# Staff Report

Re: PLNPCM2019-00620 – Design Review

**REQUEST:** A request by Gary Knapp, of JZW Architects, on behalf of the property owner, Josh Poticha, for Design Review to construct a canopy for outdoor dining at approximately 1465 South 700 East. The proposed canopy would extend into the 15 foot required setback approximately 12 feet. The CN (Neighborhood Commercial) District allows for the reduction of the front or corner setbacks through the Design Review process.

**ARCHITECTURAL SITE PLAN**  
1" = 10'-0"

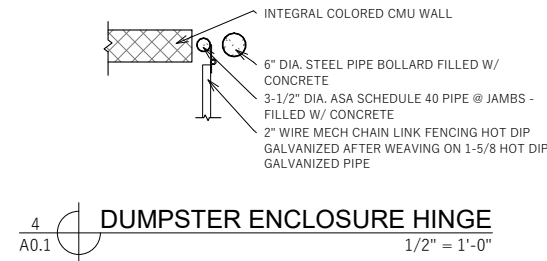
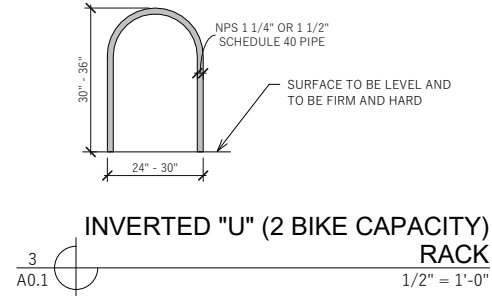
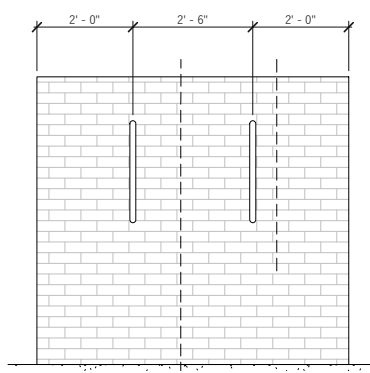
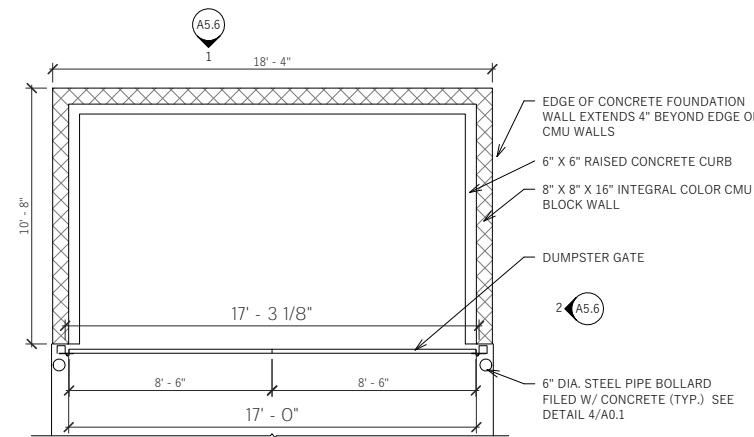
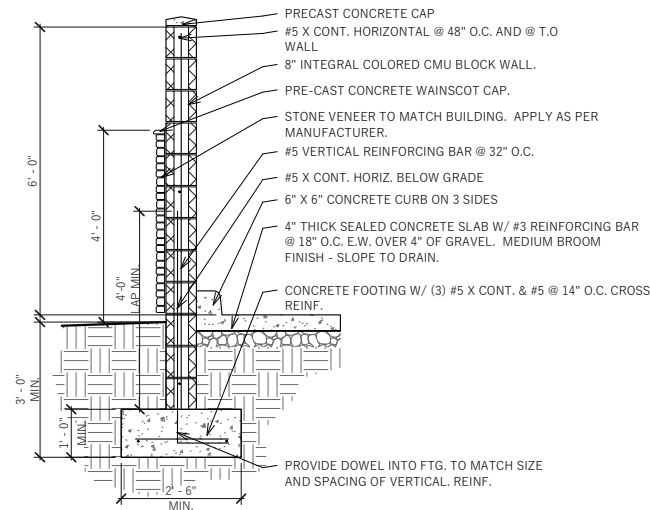
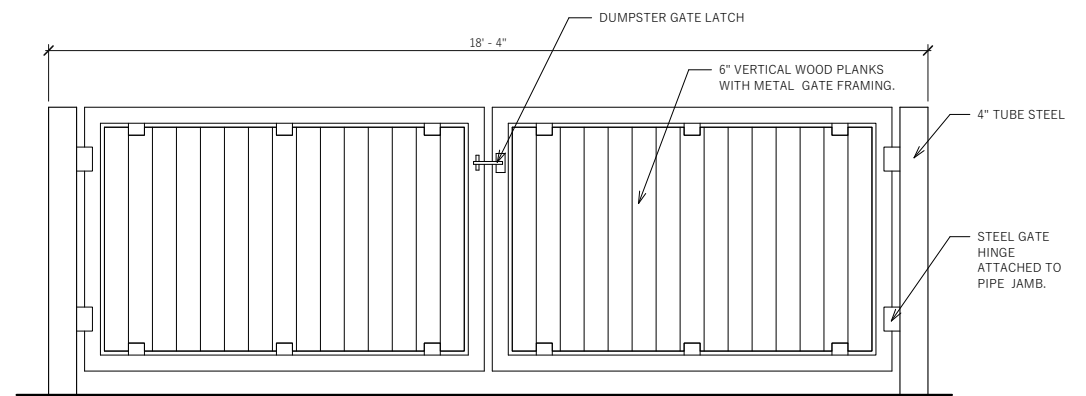
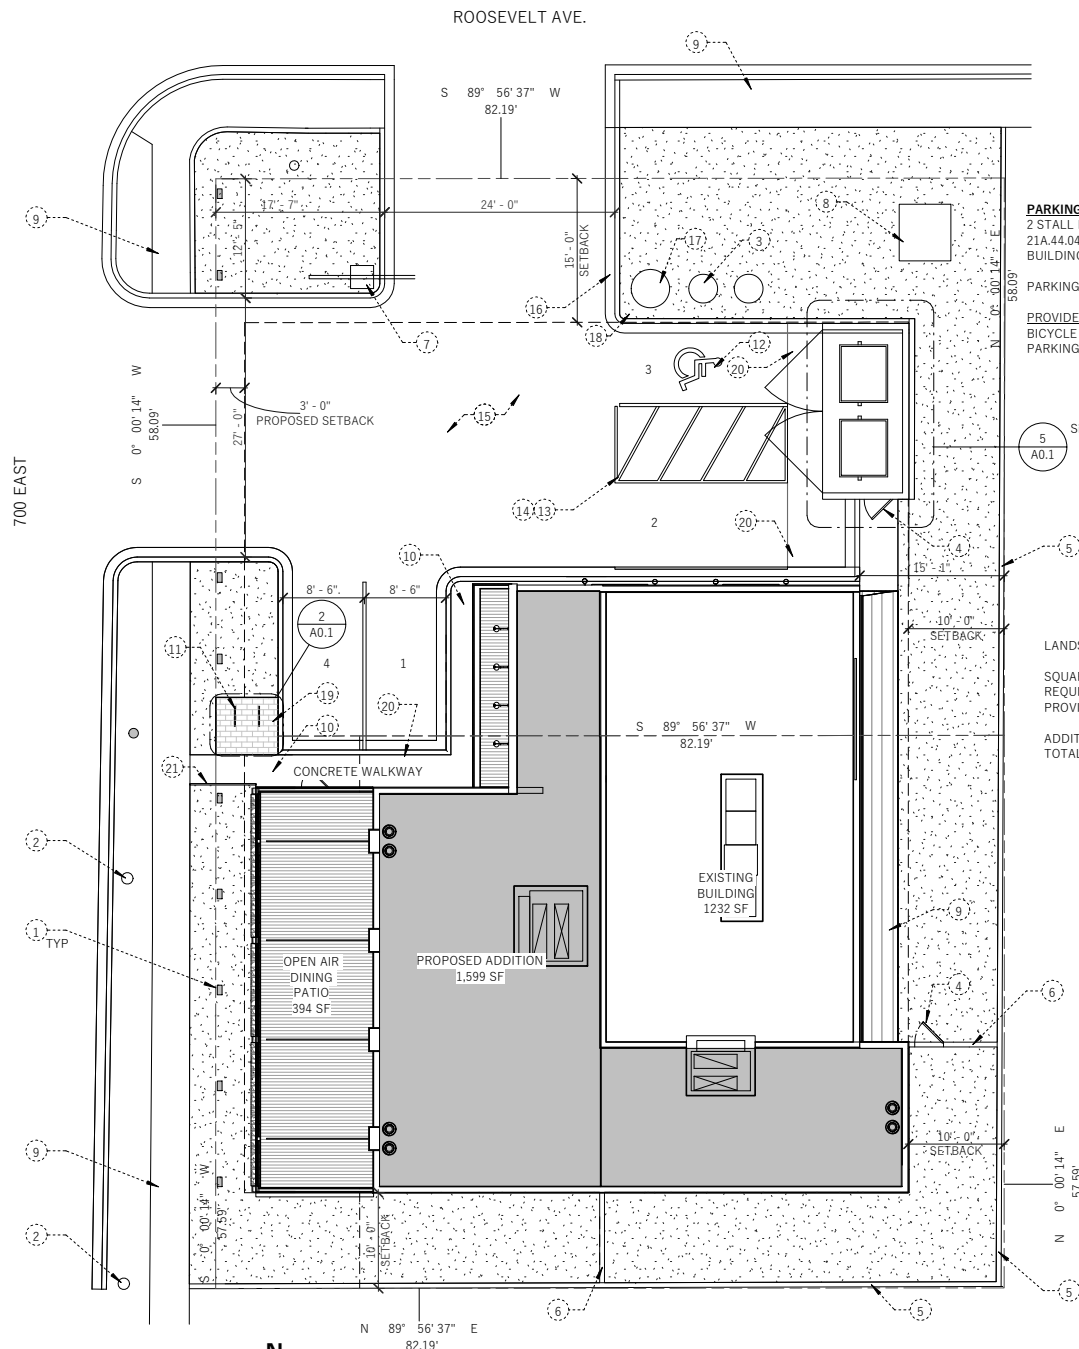
There are no zoning issues regarding the outdoor dining canopy encroachment into the front setback along 700 east. However, the plans show a ground mounted transformer located in the front yard setback along Roosevelt Avenue which will need to be resolved by relocation, special exception or a redefining of the buildable area of the lot through the conditional building and site design review.

1 ENLARGED DINING PATIO 3/8" = 1'-0"

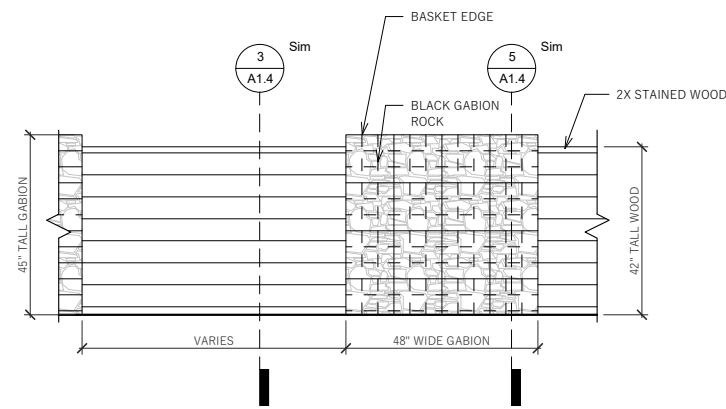
The resubmitted plans need to show the intended structural framing and foundation for the patio having a bearing condition along the property line at 7th East. The other plan review comments will need to be addressed by the architect.
